Amendment # 2

Approved Building Consent Document

TODD RESIDENCES - 53 EDWARD AVENUE - CHRISTCHURCH

SECTION B-B

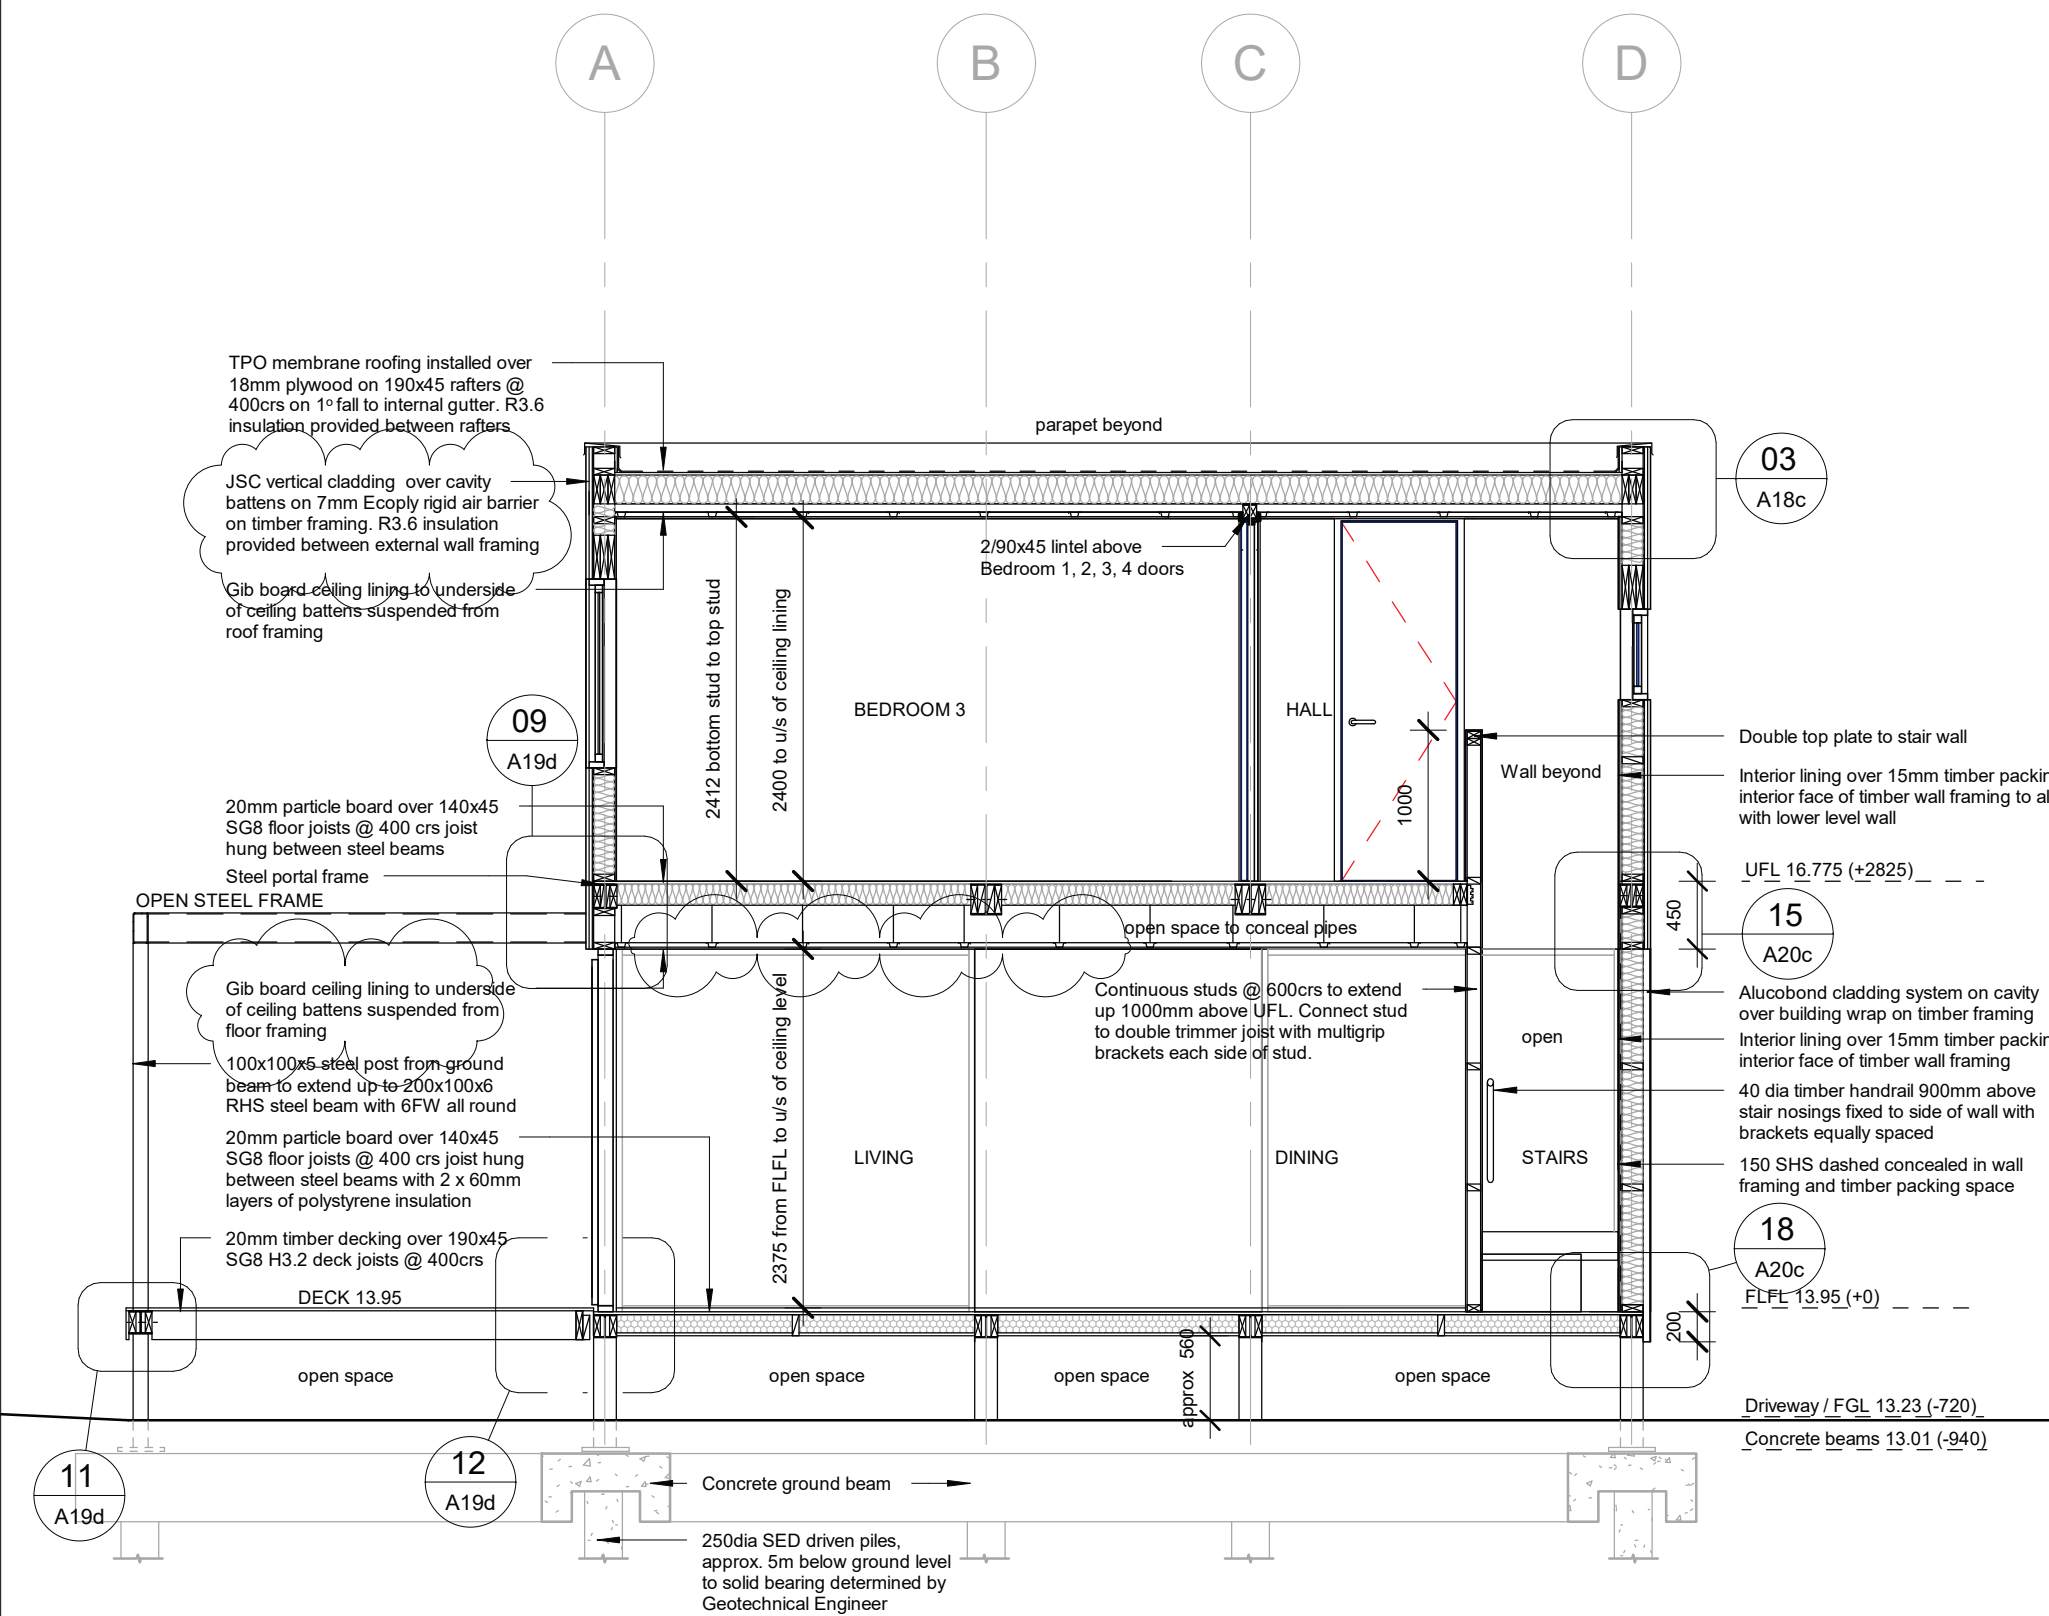
Amendment A - 12/06/17
Add exposure note regarding
stainless steel fixings.
R values for insulation shown.

Amendment B - 06/11/17
JSC Vertical Cedar Cladding changed to Innotec Vertical Shiplap Cladding. Plywood soffits have been replaced by Innowood Soffits on Lower level and Gib board ceiling on Upper level. Entrance porch and steps removed. Front entry door changed to glazed full height window.
Sail by owner within steel frame added to Deck / Outdoor area.

Amendment C - 03/04/18
Front entry glazed full height
window W1 reduced to 600 wide.
Innoclad Vertical Shiplap Cladding
and Soffit changed back to JSC
Verticlad cladding.

Amendment D - 30/04/18
Soffit construction changed back to JSC cedar verticlad cladding fixed to metal ceiling battens suspended from timber joists.

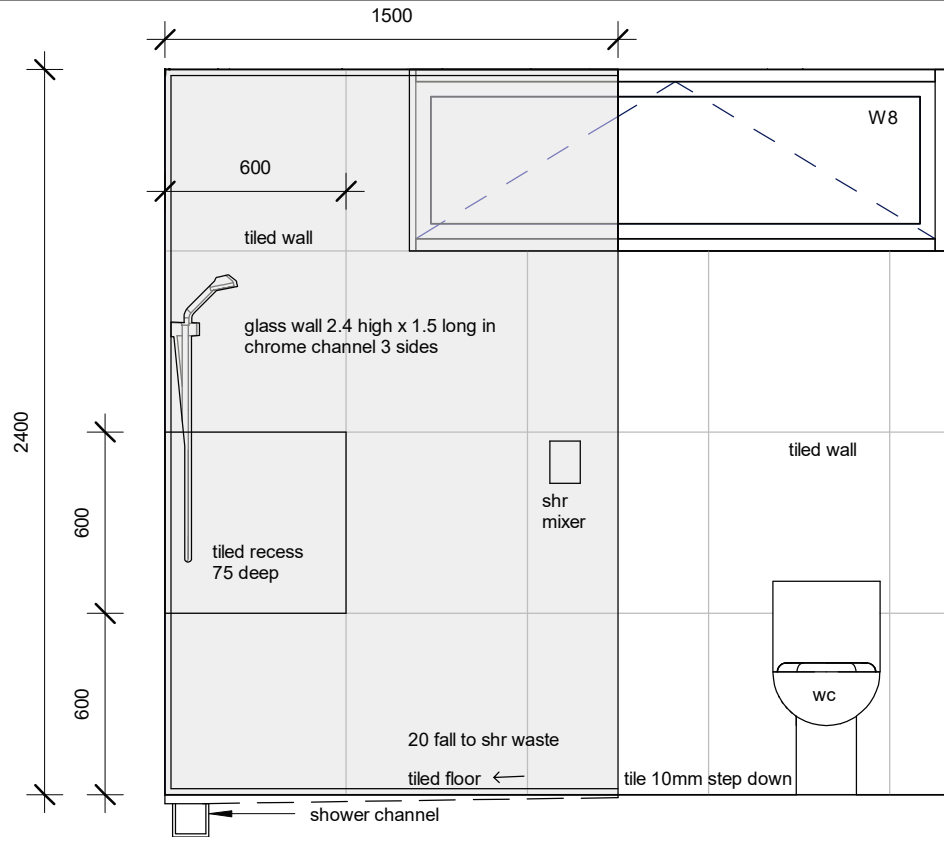
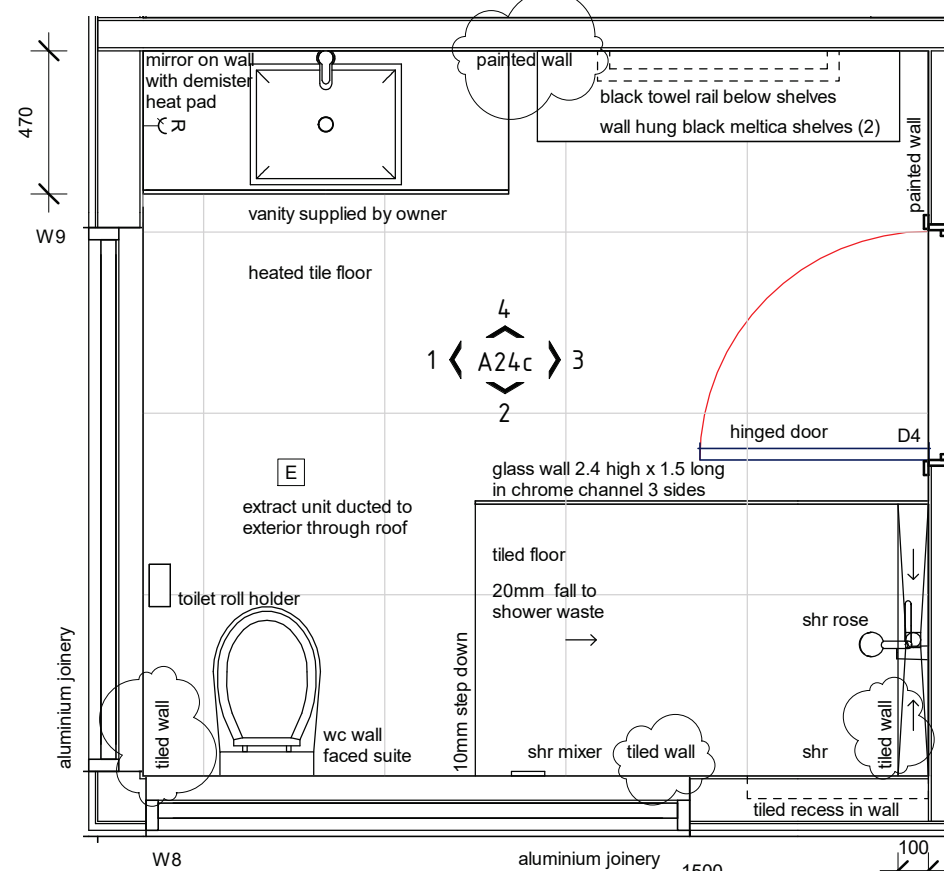
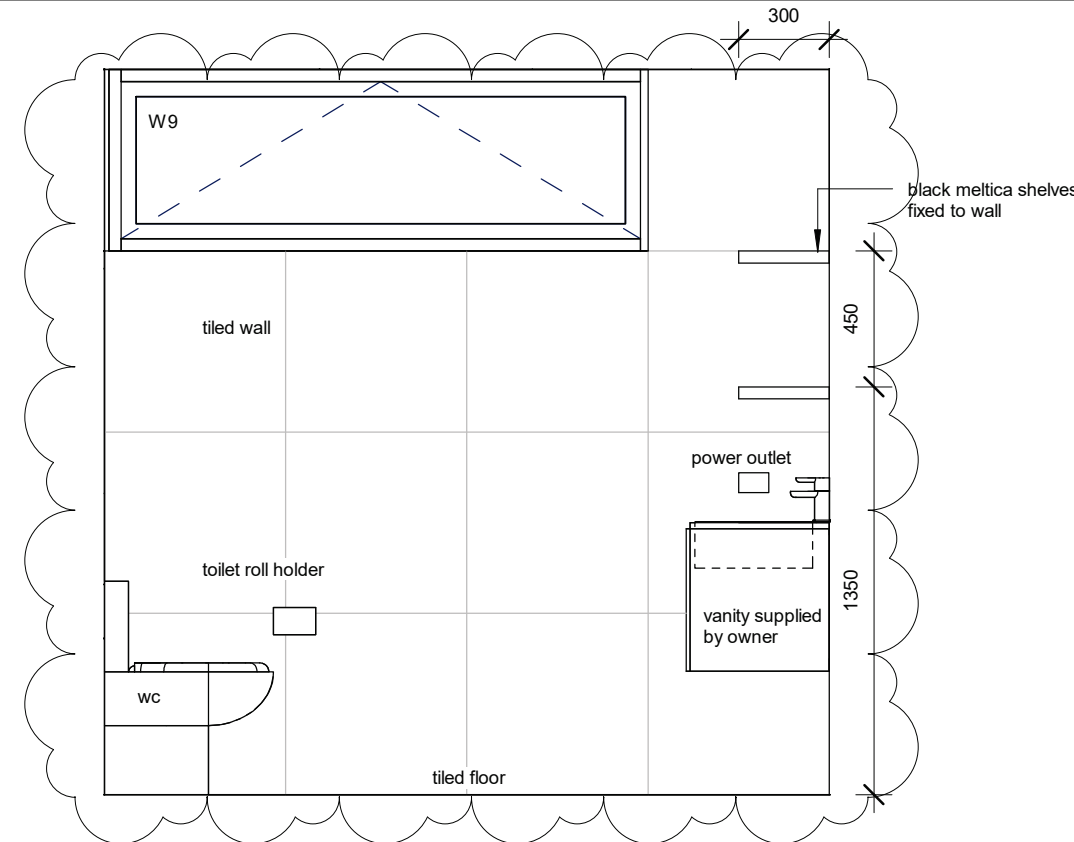
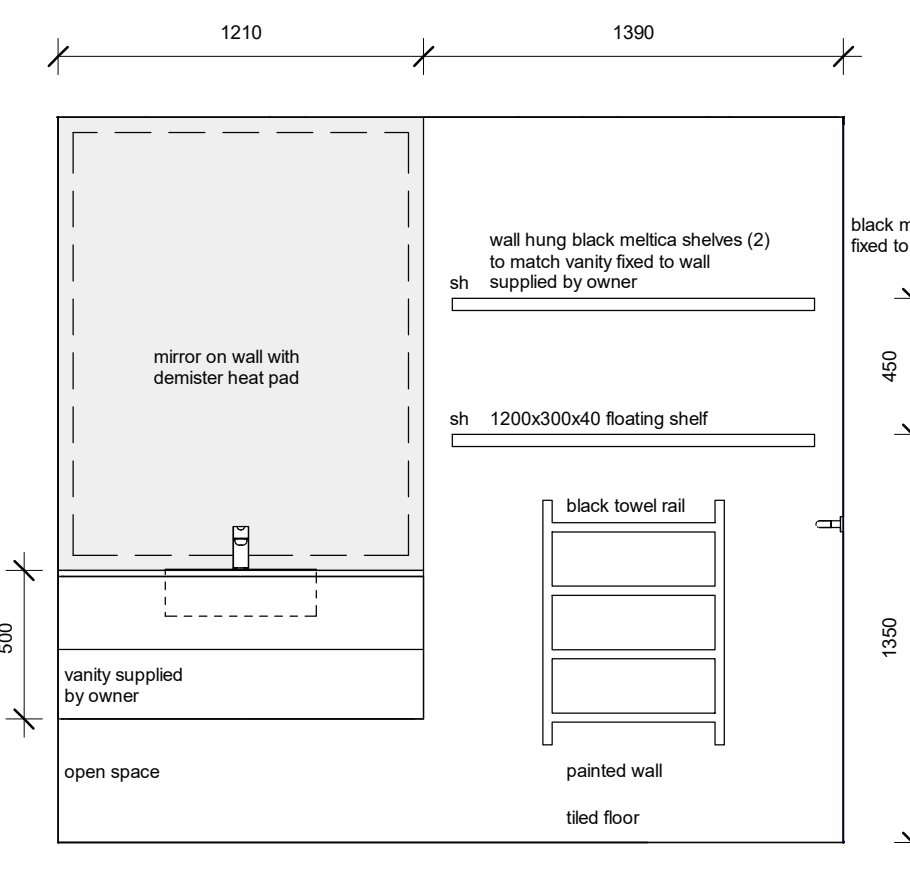
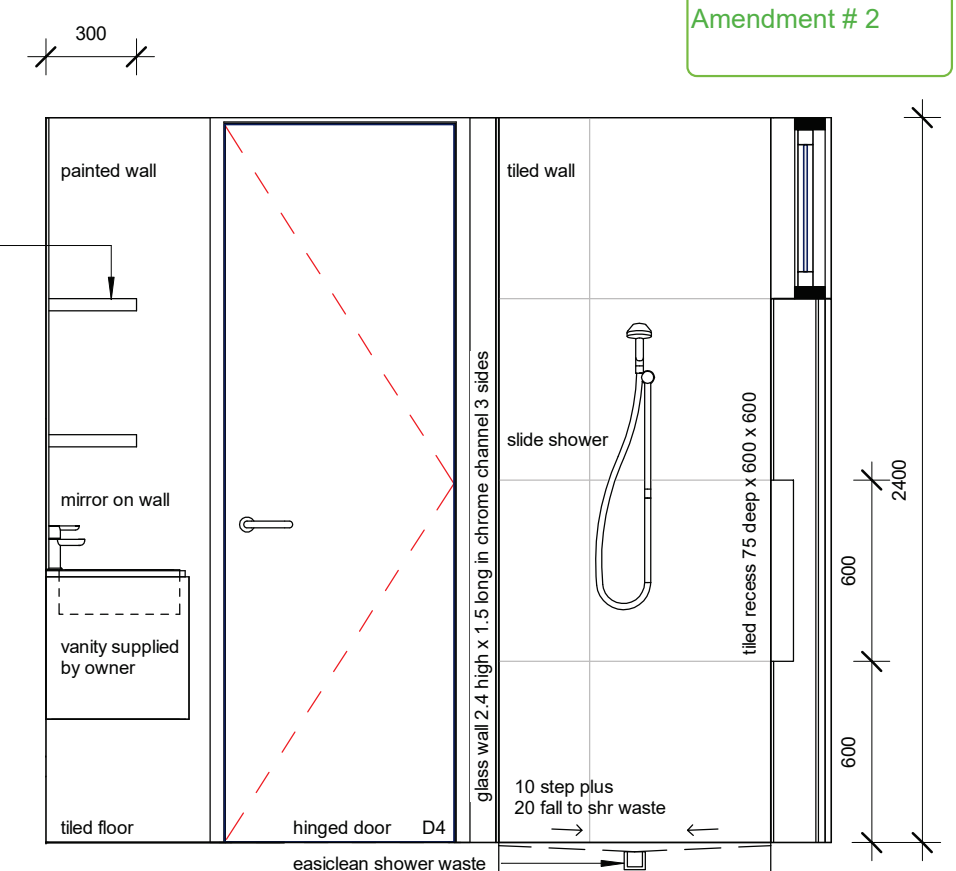
Amendment A - 30/04/18
Laundry wall shortened to
provide access to under the stair.

Amendment B - 30/05/18
Laundry joinery and benchtop
changed. Tub changed to
stainless steel.

Amendment C - 17/06/18
Laundry sliding door replaced
with bi-fold doors. Heat pump
location moved to stair wall.

Storage Elevation

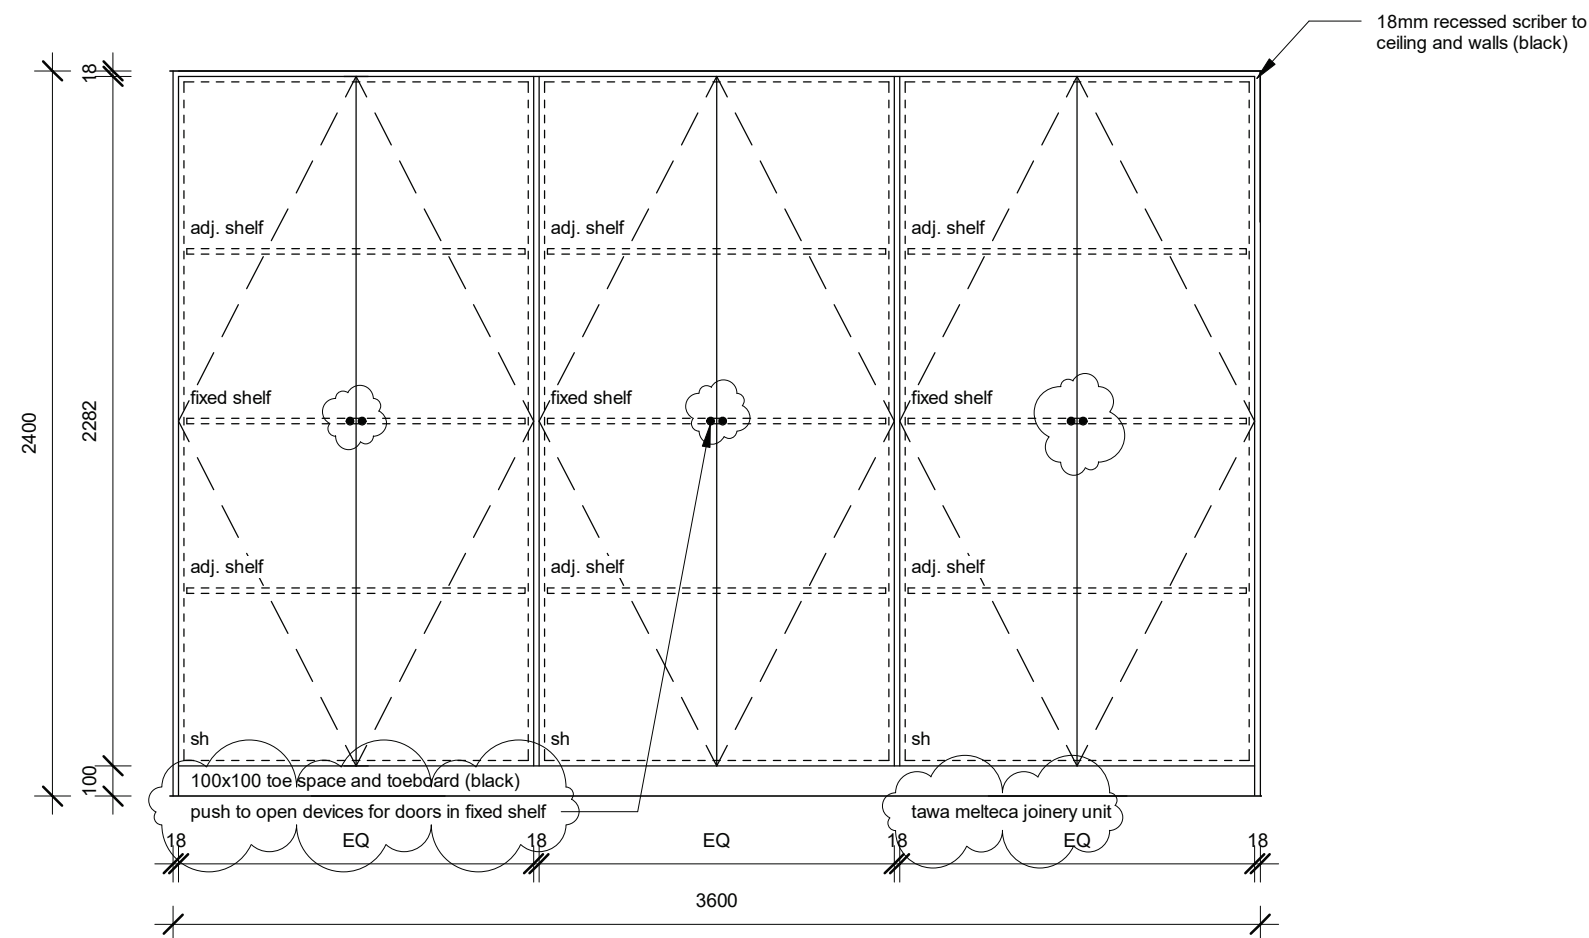
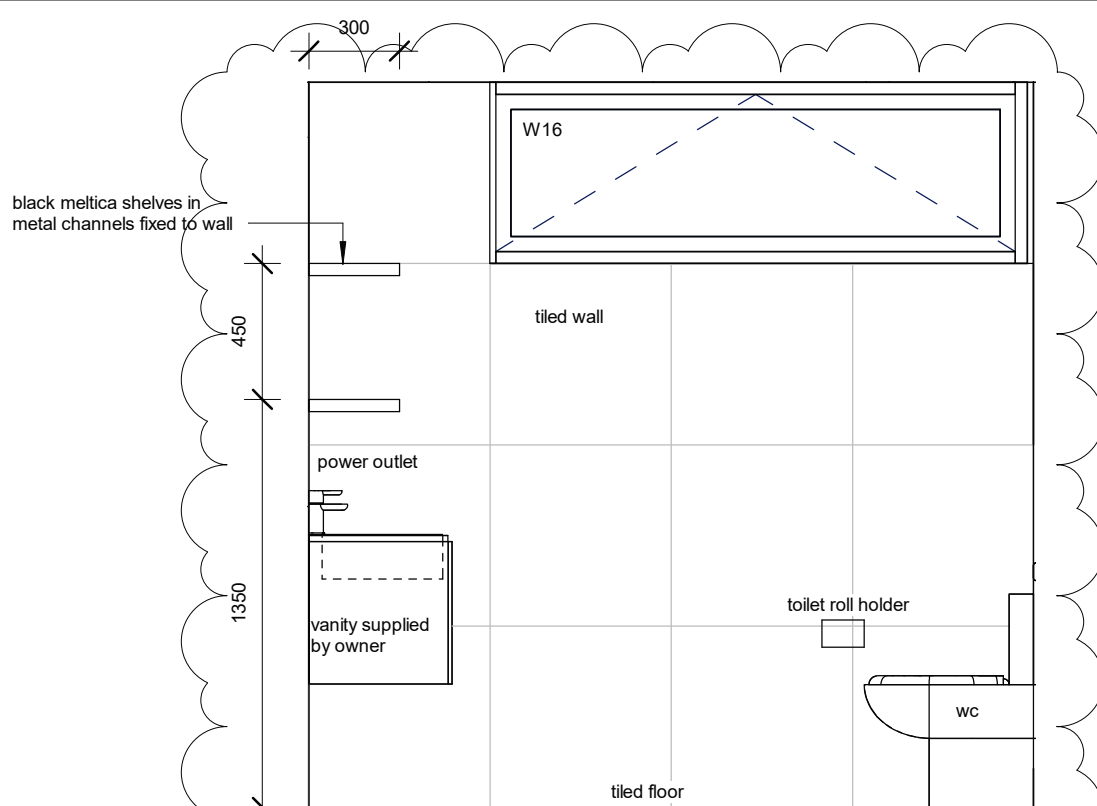
Amendment A - 30/05/18

Storage joinery recessed handles replaced with push opening devices and melteca colour updated.
